UNITED STATES PATENT AND TRADEMARK OFFICE

APPLICATION NO.	FILING DATE	FIRST NAMED INVENTOR	ATTORNEY DOCKET NO.	CONFIRMATION NO.
10/091,854	03/06/2002	William E. Blaha	439	8593

Office Action Summary

DETAILED ACTION

EXAMINER'S ATTACHMENT 1

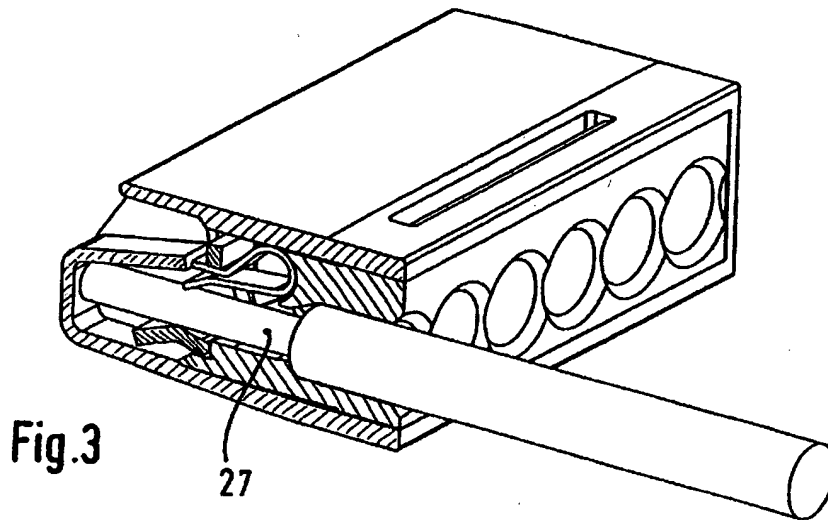
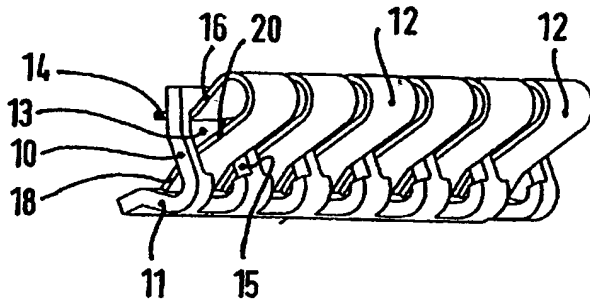
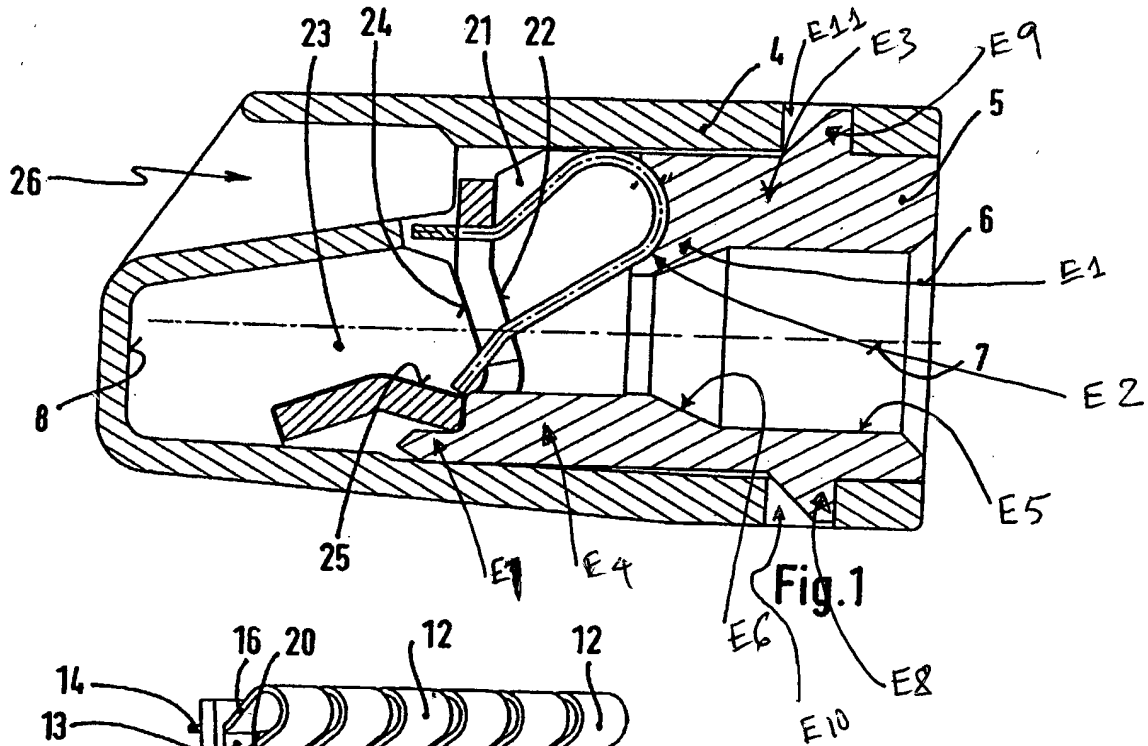
Regarding claims 5 and 17, Hartmann et al. disclose the cap having plurality of retainer lugs (E1, see examiner's attachment 1) and a first edge of the busbar engaging the lug to retain the first edge in a fixed position in the housing (see Figures 1 and 3).

Regarding claim 7, Hartmann et al. disclose the cap has a front portion (E3, see Examiner's attachment 1) and a telescoping portion (E4, see Examiner's attachment 1), the telescoping portion fitting inside the case.

Regarding claim 8, Hartmann et al. disclose the entry ports formed in the front block comprises a cylindrical saddle portion (E5, see Examiner's attachment 1) and a conical guide portion (E6, see Examiner's attachment 1).

Regarding claim 9, Hartmann et al. disclose the front block defining a recess (retainer the lug E1 and the angled edge E2) for receiving the pressure spring.

Regarding claim 10, Hartmann et al. disclose the front block defining an angled wall (E2, see Examiner's attachment).

Regarding claim 20, Hartmann et al disclose a plurality of retention tabs (E8, E9, see Examiner's attachment 1) and a plurality of retention slots (E10, E11, see Examiner's attachment 1) formed in the cap and the case respectively to hold the cap and the case together.

at least one projection (E1, see Examiner's attachment) extending into the enclosure;

EXAMINER'S ATTACHMENT 2

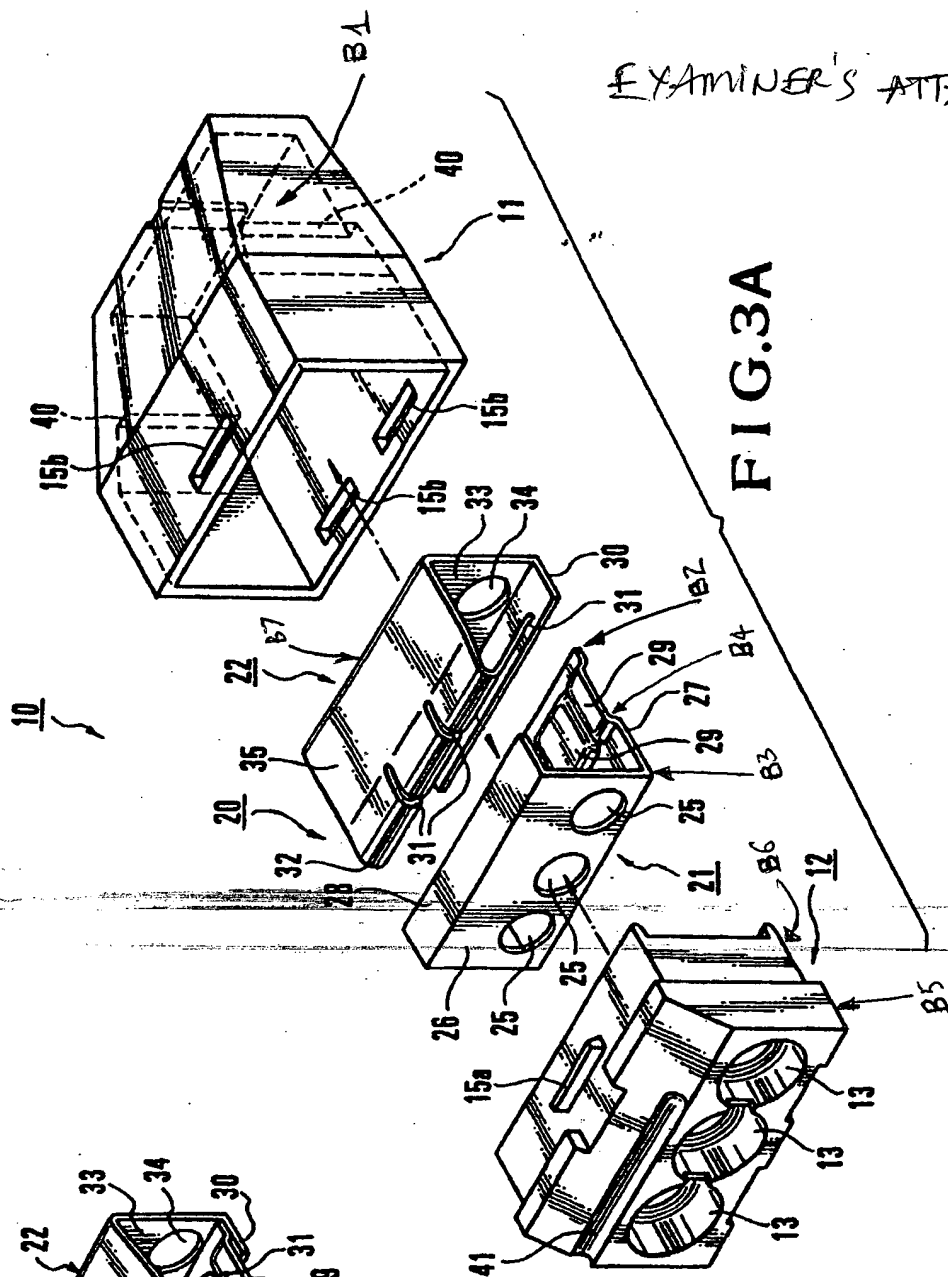
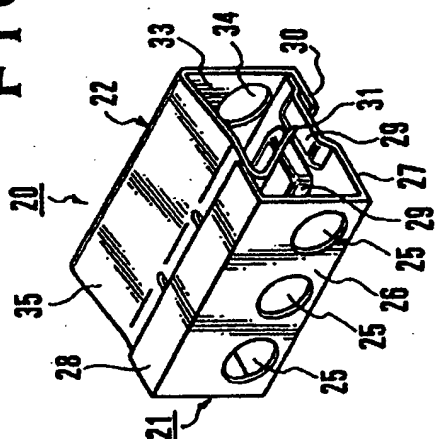
a conductive bus bar (21) having first and second edge (B2, B3 see Examiner's attachment 2) being supported in the case and the cap respectively.

Regarding claim 14, Tozuka discloses the pressure spring comprising a base plate (35) having a first edge and a second edges (B7, 32 see Examiner's attachment) being supported in the case and the cap respectively (see Figure 1).
